THM 4L80-E 1994 OUTPUT SPEED SENSOR ELIMINATED

CHANGE: Beginning at the Start Of Production for the 1994 model year, all 4WD models only of the

THM 4L80-E/4L80-EHD transmissions have revised vehicle speed sensor wiring circuits

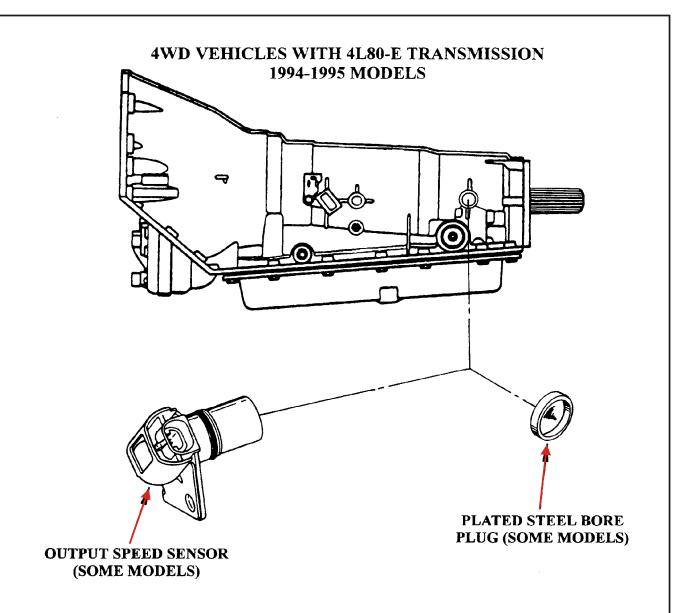
(1) TRANSMISSION OUTPUT SHAFT SENSOR (TOSS) - Eliminated on 4WD models only, and a plated steel expansion plug was installed in the case bore (See Figure 1). All 4WD models now use the Output Speed Sensor located on the transfer case as the only vehicle speed information sent to the speed buffer (See Figure 2).

NOTE: The Output Speed Sensor Bore Plug may fall out, or fluid may leak past the bore plug. Beginning on January 2 1, 1994,4L80-E, 4WD models will have a speed sensor installed in the output speed sensor bore in the transmission case.

THE SPEED SENSOR IS USED AS A PLUG ONLY. IT WILL NOT BE ELECTRICALLY CONNECTED.

Figure 2

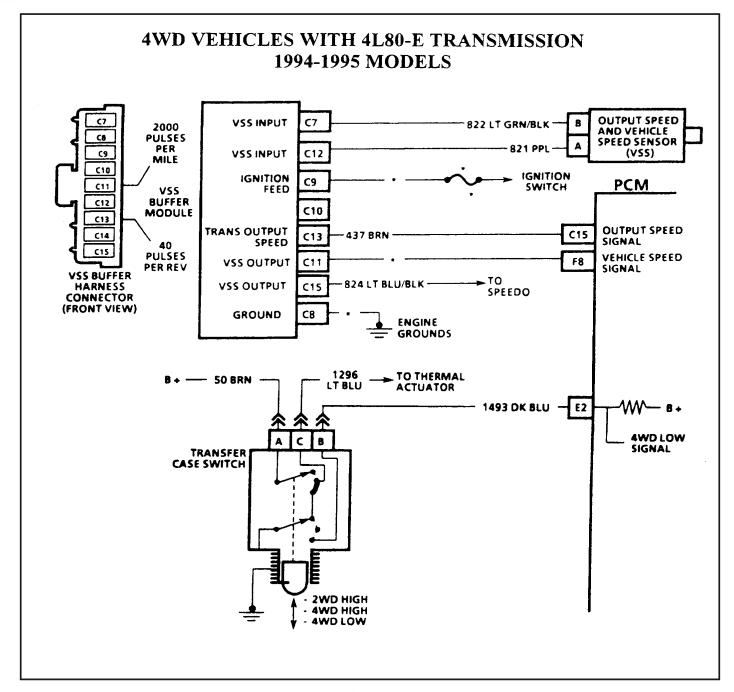
- (2) TRANSFER CASE SWITCH Previously used to energize the front drive axle thermal actuator, now has an added set of contacts incorporated inside the switch, and an added wire to signal the PCM/TCM when the am LOW range is selected. (See Figure 2).
- (3) SPEED SENSOR ROTOR Located on the Output Carrier, has been eliminated on 1994-1995 4u1) models only, as there is no longer a need for it, and is a cost savings. Care should be used to ensure that a late Output Carrier without the Speed Sensor Rotor, does not inadvertently get into a 2WD transmission (See Figure 3).

CAUTION: The Output Speed Sensor Bore Plug may fall out, or fluid may leak past the bore plug. Beginning on January 21, 1994, 4L80-E 4WD models will have a speed sensor installed in the output speed sensor bore in the transmission case.

THE SPEED SENSOR IS USED AS A PLUG ONLY. IT WILL NOT BE ELECTRICALLY CONNECTED.

Figure 3

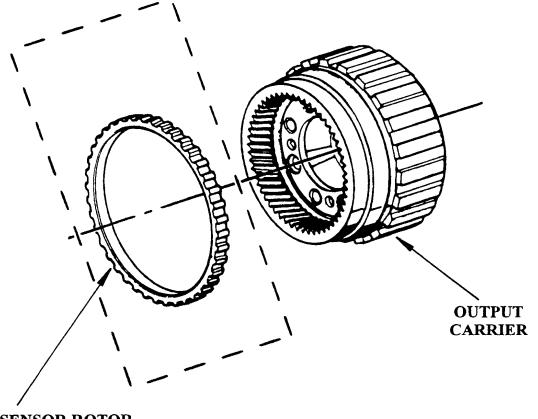
SPEED SENSOR ROTOR ELIMINATED ON 1994 AND 1995 4WD MODELS ONLY

CAUTION: TWO WHEEL DRIVE TRANSMISSIONS MUST HAVE SPEED SENSOR ROTOR INSTALLED.
